Orsted Onshore Ireland Midco Limited

5: MEMORANDUM RESPONSE TO SUBMISSIONS RECEIVED

HYDROLOGY & HYDROGEOLOGY

Proposed Oatfield Wind Farm Project, Co. Clare: ABP
Case No. ABP-318782-24

Figure 3.1: Wind farm hydrology

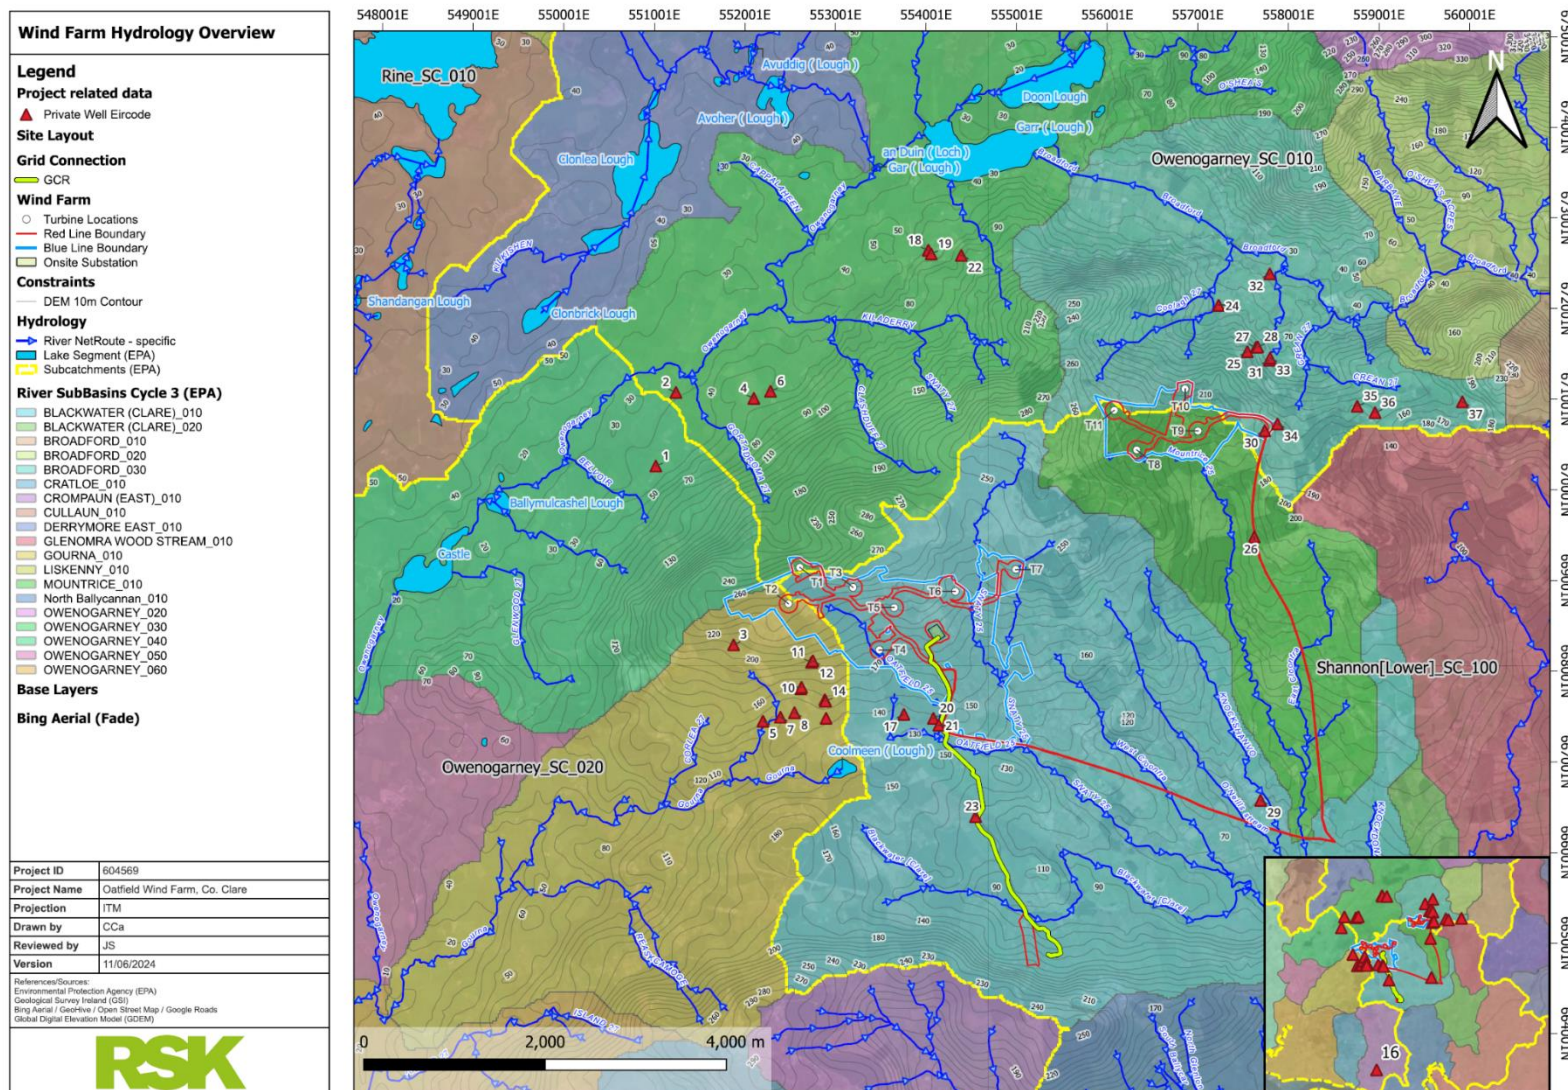
Submissions raised concerns of potential pollution on local water network/systems and under SDG6 upland areas need “to be protected and not damaged through the development of large industrial construction projects such as the Proposed Development”.

All downstream hydrologically linked surface waters (mapped rivers, lakes, transitional waters and coastal waters) have been identified and outlined in Section 9.3.5 and Section 9.3.15 of **EIAR Chapter 9**. These are also presented in Figure 9.3 of **EIAR Chapter 9** which has been appended to this response document (**Appendix 1**). These receptors range from less than 1km Oatfield_25 & Snaty_25 river water bodies up to 93.5km to the nearest coastal waterbodies downstream [Mouth of the Shannon].

River subbasins that the works take place in are presented in Figure 3.1. In the WDA, there are three river subbasins, outlined below with the level of works taking place in these areas.

- The Blackwater (Clare)_010; containing five (5 no.) turbines and the substation
- Gourn_010; containing one (1 no.) turbine
- Owenogarney_010; containing one (1 no.) turbine

In the EDA, there are two river subbasins which are outlined below with the level of works taking place in these areas.

- Mountrice_010; containing three (3 no.) turbines
- Broadford_010; containing one (1 no.) turbine

Figure 3.2: Private mapped wells and GSI mapped wells in the vicinity of the site

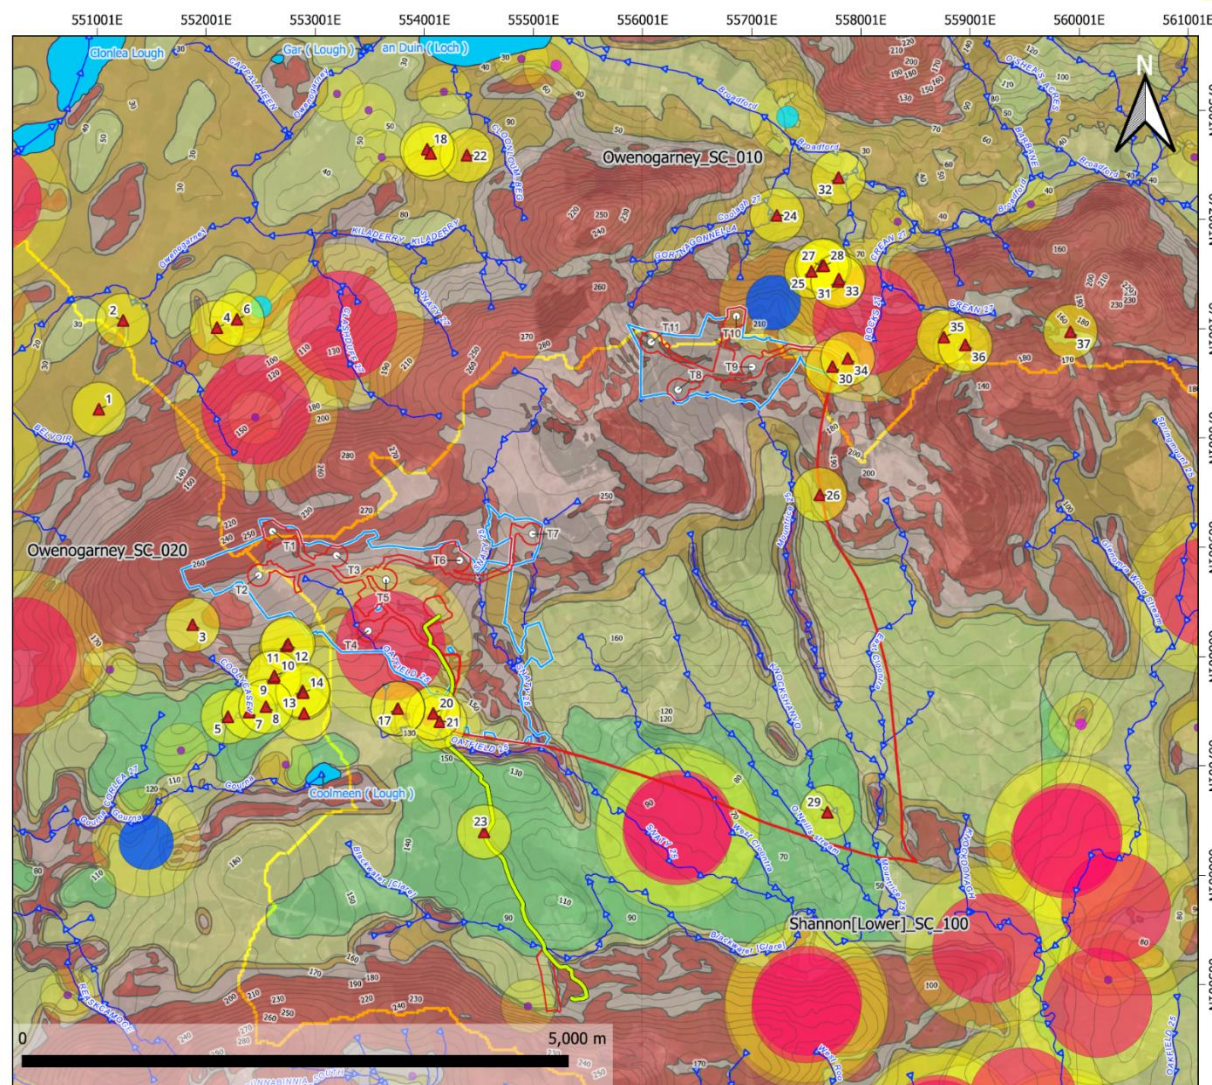
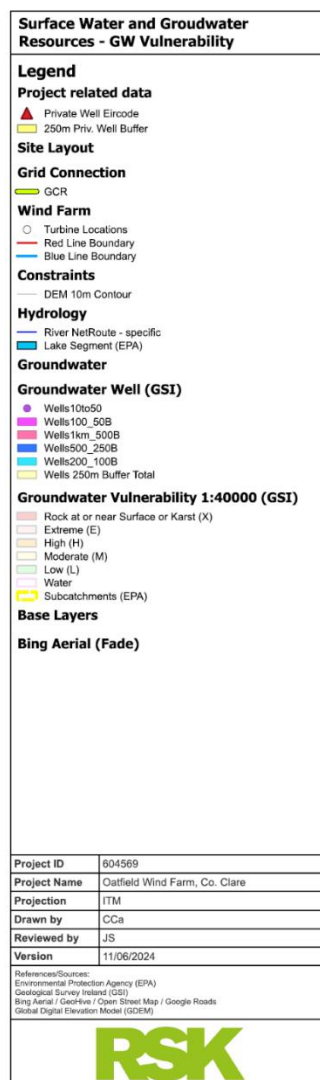
Concerns were raised regarding contaminants and hazardous materials, such as hydrocarbons, entering pathways to groundwater (for example; gravity fed system from spring water) and private drinking water wells. Concern was also raised around the potential for *contaminating the local water ways which could eventually leech into drinking water supplies*. Groundwater vulnerability was raised as a concern beneath these private wells and potential effects on the water table.

dwellings are located within 2km of the Site.” These have been mapped, using Eircodes of individuals confirming ownership of a private well (using the submissions received). See Figure 3.2, with the exception of ten (no.10) submissions that did not include Eircodes. This map also shows the river subbasin which these dwellings are in and the level of infrastructure (potential effects by works) that falls into those catchments. Private wells are numbered from west to east. All wells; private and GSI mapped have been allocated a buffer of 250m.

The nearest dwellings were outlined in **EIAR Chapter 9**, Section 9.4.3.13 and are also summarised below in Table 3.1 and presented in Figure 3.2. This table has now been updated to outline all confirmed dwellings with wells. The associated river subbasin is outlined below and the nearest turbine in that river subbasin identified. The level of potential contamination is based on the magnitude of works in that subbasin.

To protect groundwater, the construction on greenfield areas are outside buffers placed on wells, the aquifers underlying these wells are designated as LI and PI (see Figure 3.2). Groundwater vulnerability classed as X indicates rock at the surface. The risks to groundwater associated with the site are low.
